CITY OF FORT LAUDERDALE

CASE COMMENT REPORT

CASE NO. UDP-S24065

CASE:	UDP-S24065
MEETING DATE:	November 26, 2024
REQUEST:	Site Plan Level II Review: 1,729 Square-Foot Professional Office Use with Associated Parking Reduction Request
APPLICANT:	Grimaldi & Weiss Management, LLC.
AGENT:	Alexander Mohr, John J. Doyle Development Corp.
PROJECT NAME:	Grimaldi & Weiss Management Office
PROPERTY ADDRESS:	648 NW 22nd Road
ZONING DISTRICT:	Community Business (CB)
LAND USE:	Northwest Regional Activity Center
COMMISSION DISTRICT:	3 – Pamela Beasley-Pittman
NEIGHBORHOOD ASSOCIATION:	Durrs Community Association
CASE PLANNER:	Yvonne Redding

The proposed office building located at 644 NW 22nd Road (adjacent lot), has proposed the below:

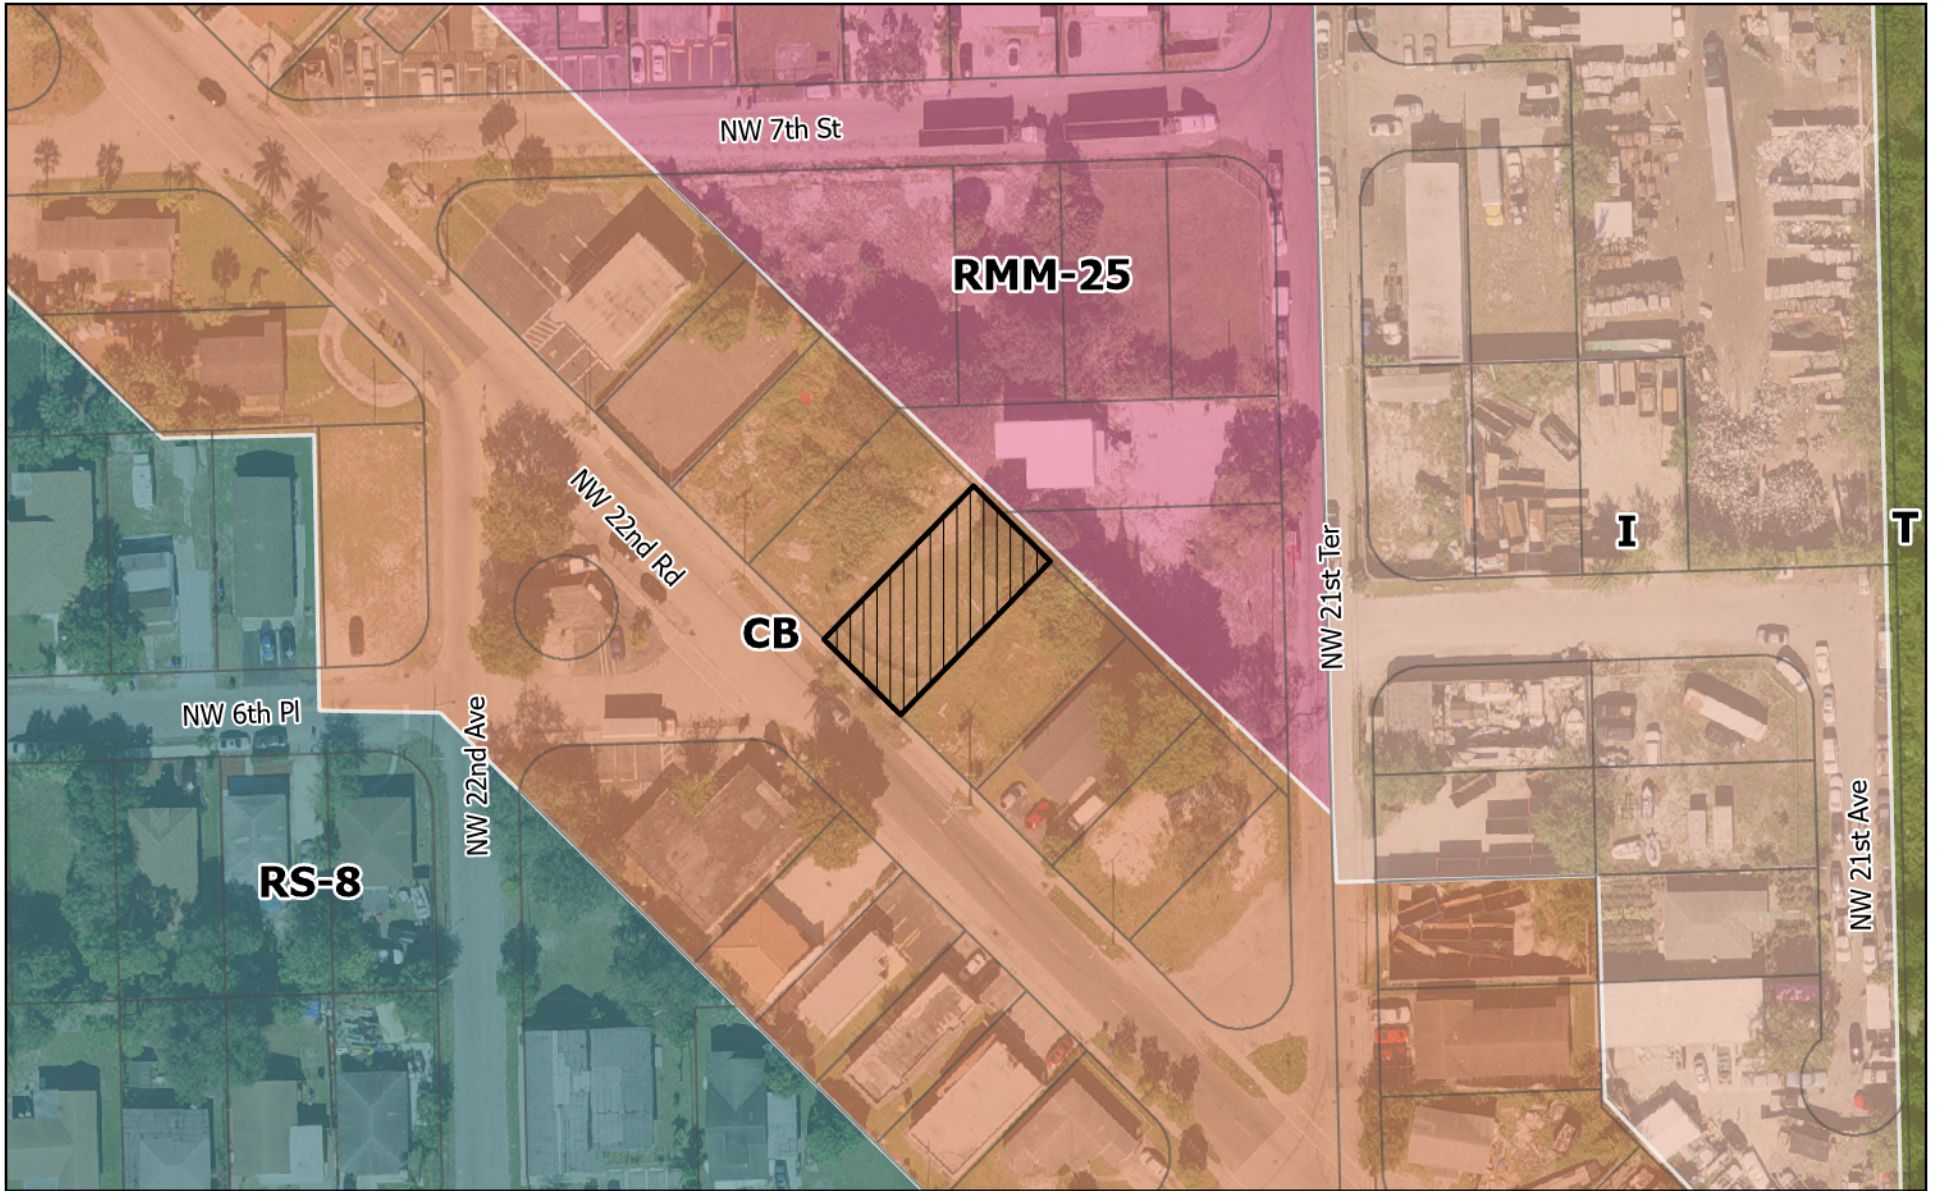
- 5) Provide the following changes on site plan/floor plan:
 - a. Clarify the proposed floor plan. It appears the intent is to divide the space into two bays. If two tenants are proposed, please indicate that in the narrative and on the site data table. Per the FBC a restroom is required for the additional bay. There may also be a FBC requirement for openings along the side (west) elevation.

- b. Reduce the drive aisle width along NW 22nd Road. It should be reduced to 20-foot wide.
 - c. Indicate location of refuse collection bins within the building and for collection.

- 6) Provide the following changes on elevations:
 - a. Reduce the height of the structure, double height is not needed for office use.
 - b. Remove the 2nd overhead door.

- c. Provide colors and materials that are more appropriate and sustainable for an office use.
 - d. The proposed windows should be lowered to provide pedestrian level perspectives.
